APPLICATION NO.	FILING DATE	FIRST NAMED INVENTOR	ATTORNEY DOCKET NO.	CONFIRMATION NO.
10/517,845	12/15/2004	Arvo Jonkka	032221-055	1312

Office Action Summary

DETAILED ACTION

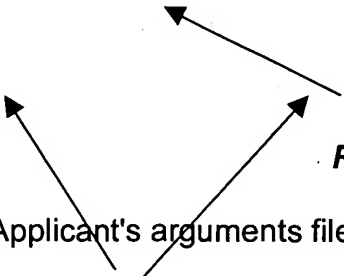
The device of either AAPA or Svensson '384 or '670 reads on the elements of the claimed invention including a method for clamping a knife on a chipper disk by forcing the knife in an inclined projecting position out from the disc against a wear plate fastened on the knife side of the disk, with a force substantially parallel to the axis of the disc, exerting said force parallel to the axis of the disc outward from the disc and directed to the knife through a clamp having a contact with the wear plate, said contact being barred in the projecting direction to the knife wherein the force parallel to the axis of the disc is exerted to the clamp at a point towards the knife tip from said barred contact point in order to bring a turning moment to the clamp as seen in figure 1 of AAPA or figure 2 of Svensson '670 or figure 8 of Svensson '384.

The device of either Svensson '670 or '384 reads on the elements of the claimed invention including a knife disc (11 or 219, respectively), a wear plate (21 or 93, respectively) substantially covering the knife side of the disc, a knife (17 or 223, respectively), a clamp (19 or 237, respectively), a compressing means (23 or 97, respectively), a bracket (see fig. 2 of Svensson or 95, respectively), a matching groove, a cam and a projection. The clamp of Holmberg or Svensson is supported against a perpendicular direction, parallel with a compressive motion, by the bracket abutting the matching groove.
